Comments on Draft Report on Kentucky Utilities – Green River Station

January 26, 2011

**Re: Kentucky Utilities' Comments on  
*DRAFT Report of Geotechnical Investigation Dam Safety Assessment of Coal Combustion Surface  
Impoundments Kentucky Utilities, a Subsidiary of E.ON U.S. Green River Station, Central City, Kentucky***

# 3143-10-1317 Green River Power Station Section 1: Downstream - SS/Max Flood

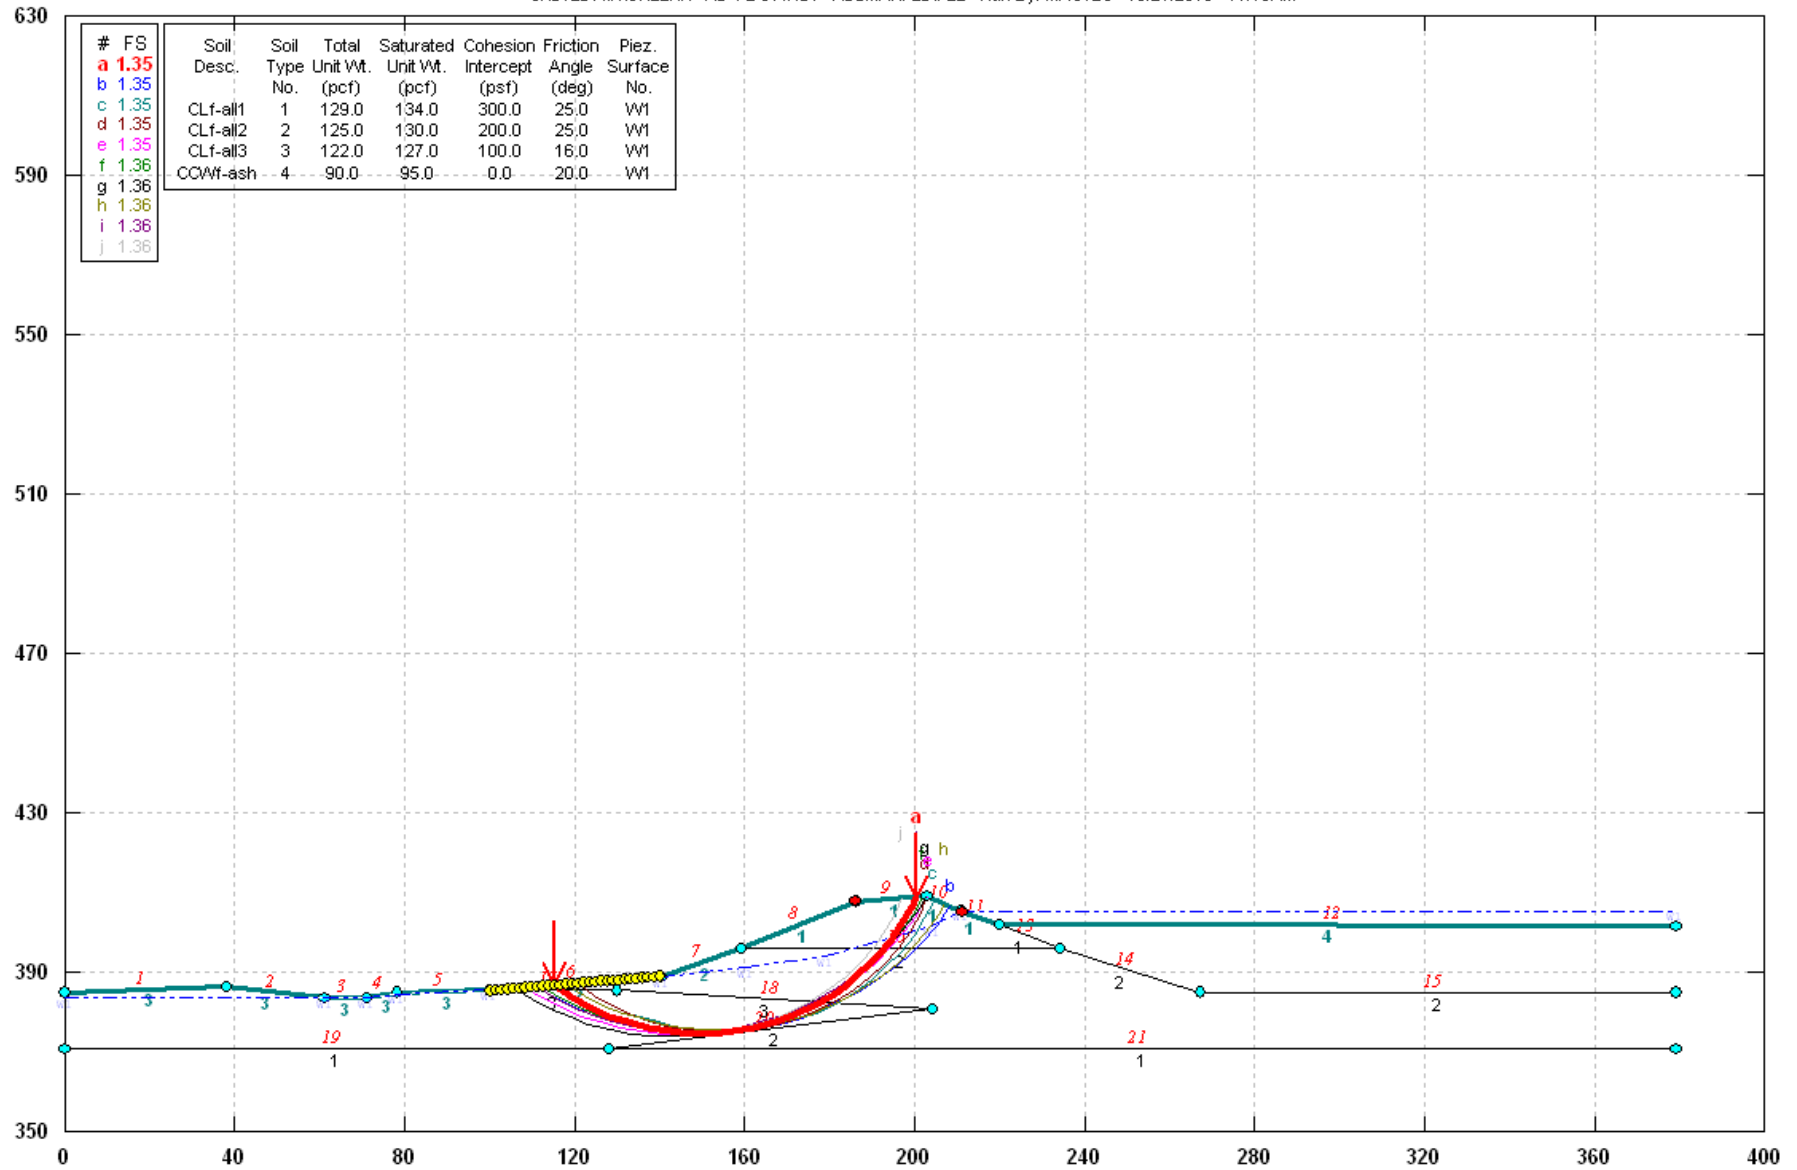
For cross section 1 of the Coal Pile Runoff Pond, the downstream model for the steady-state/maximum surcharge pool conditions indicated a theoretical minimum FS of 1.4. Theoretical factors of safety above 1.0 indicate a stable slope under modeled conditions; therefore, the slopes are currently stable and should not be expected to fail under normal operating conditions. KU is currently evaluating the results of the analysis and plans to study options to improve the section if necessary to increase the factor of safety above KY DEP recommended values.
